CITY OF ALBUQUERQUE

Re: Ulta Addition Ventura Place Bldg 3

Grading and Drainage Plan

Scott McGee's Engineer's Stamp 10-22-14 (C20D071)

C-101

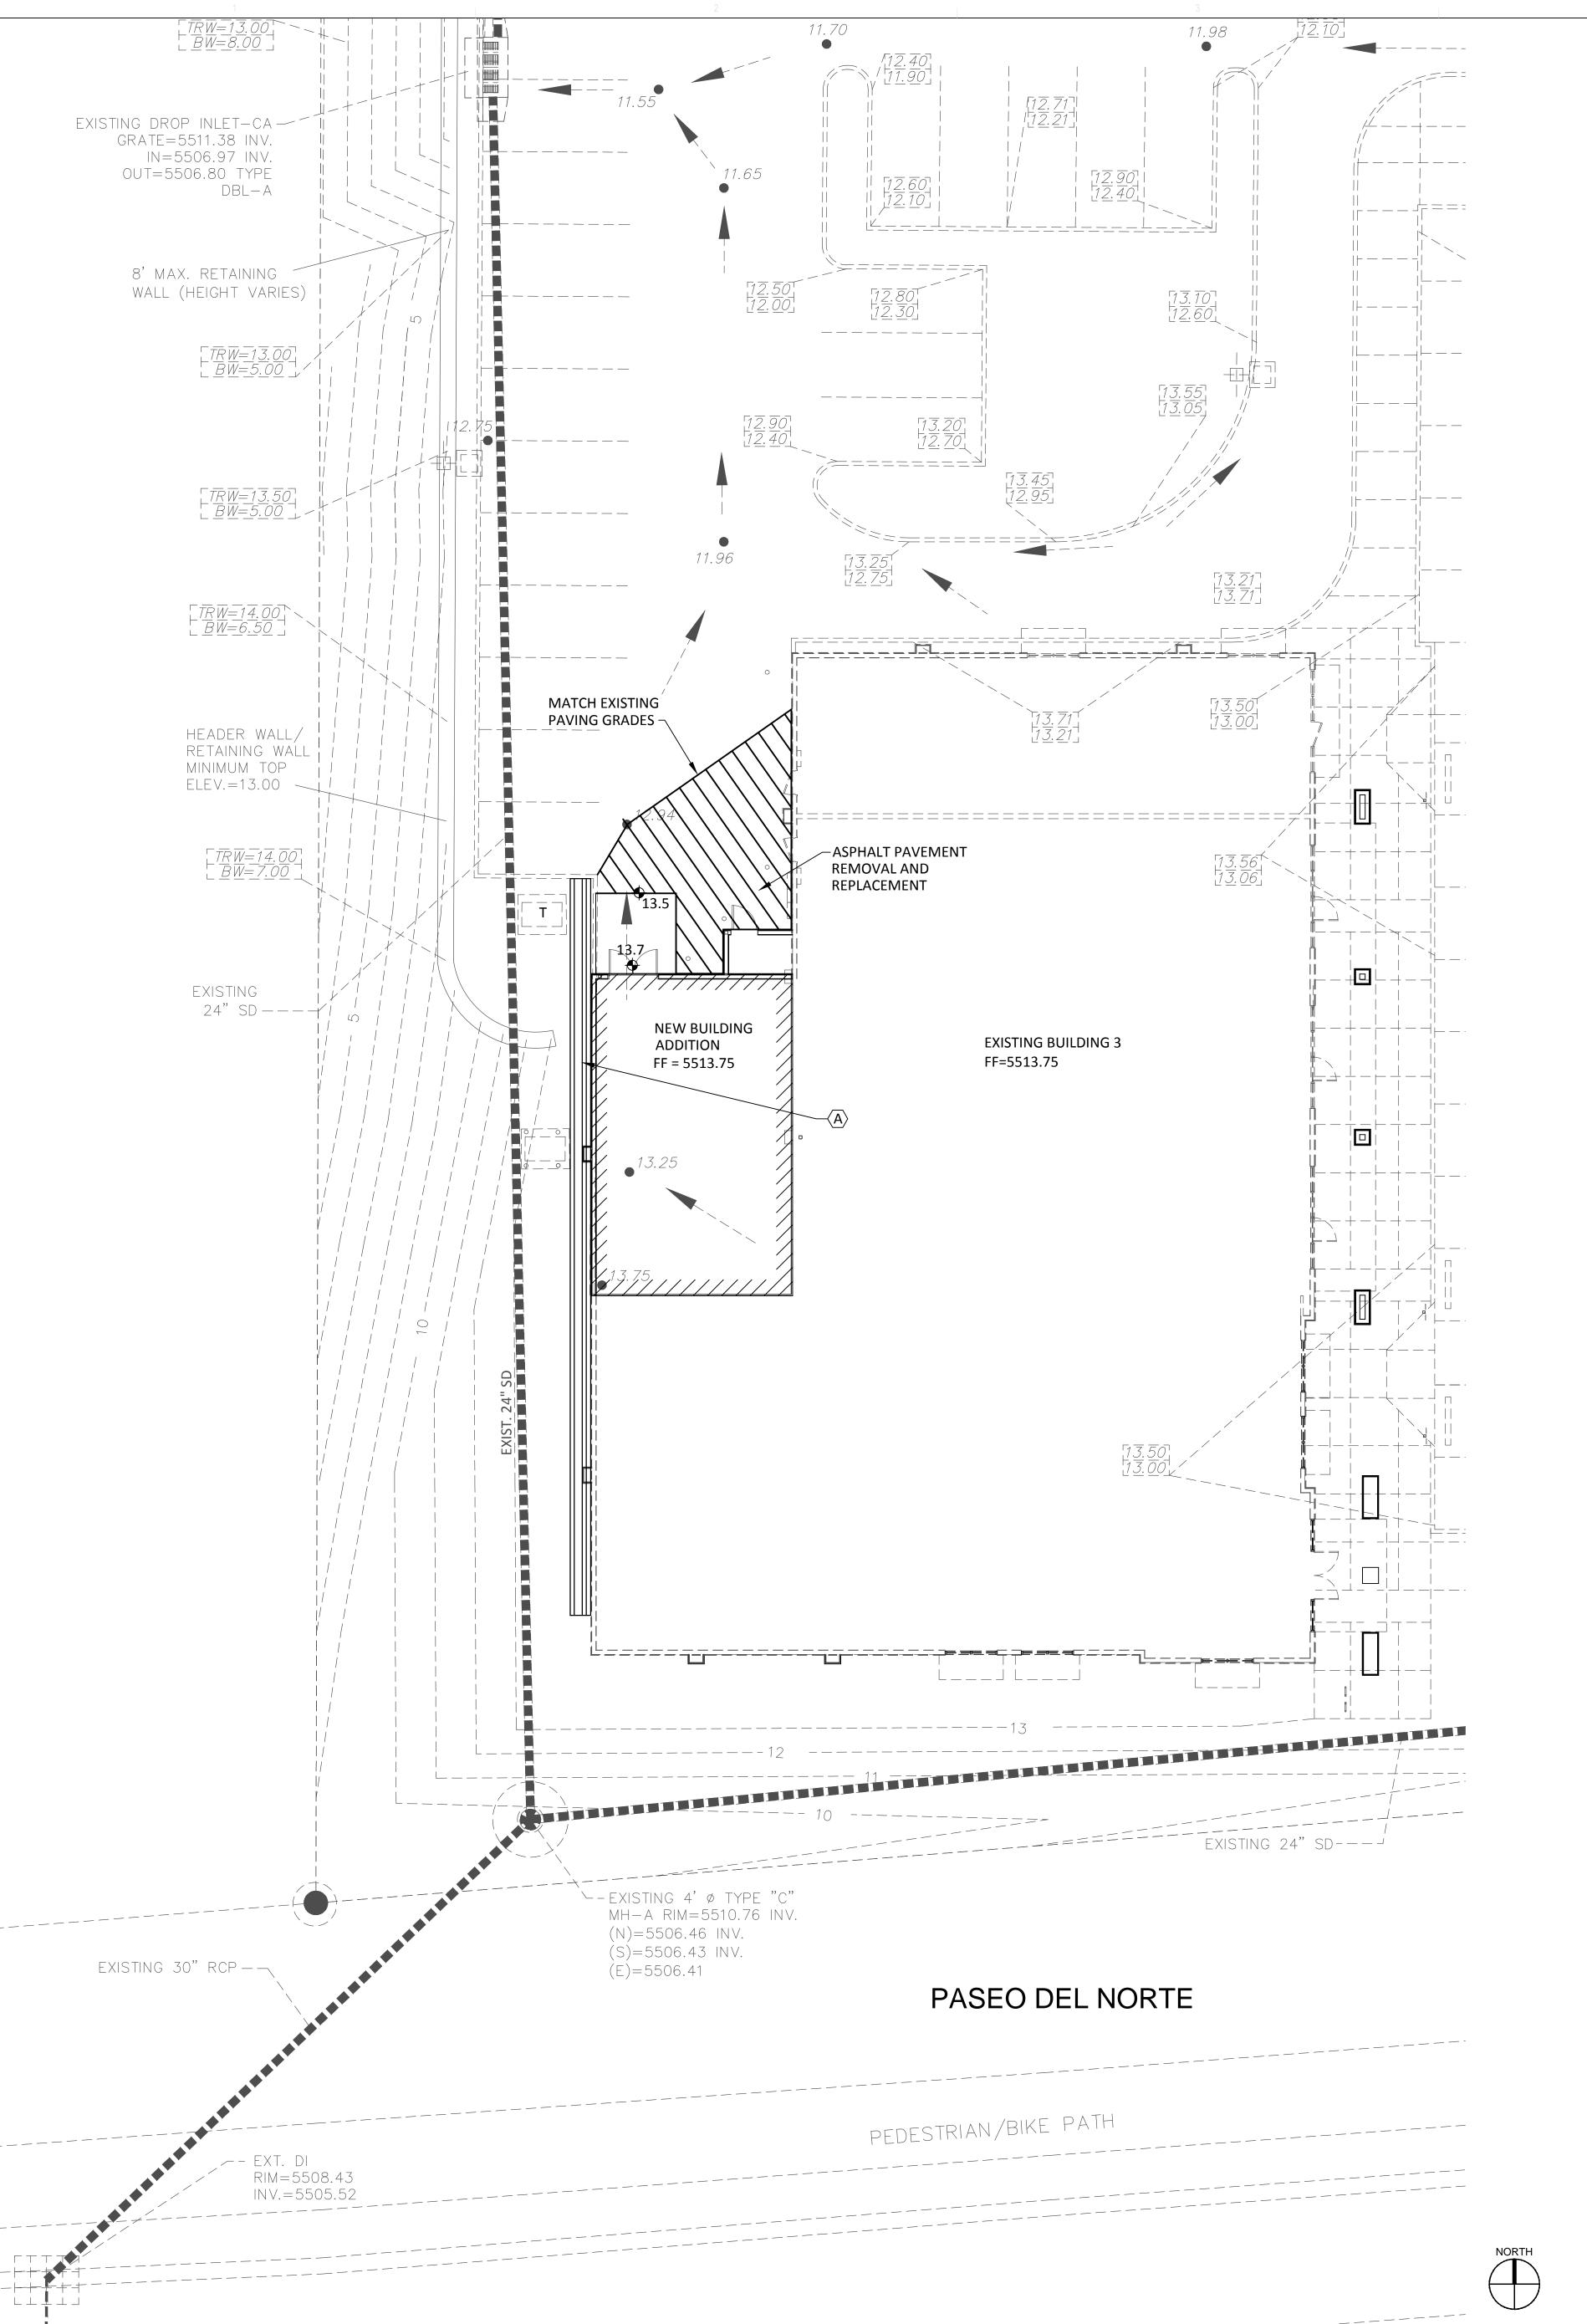
Based upon the information provided in your submittal received October 27, 2014, the above referenced plan is approved for Building Permit. Please attach a copy of this approved plan to the construction sets prior to sign-off by Hydrology.

Prior to Certificate of Occupancy release, Engineer Certification per the DPM checklist will be required.
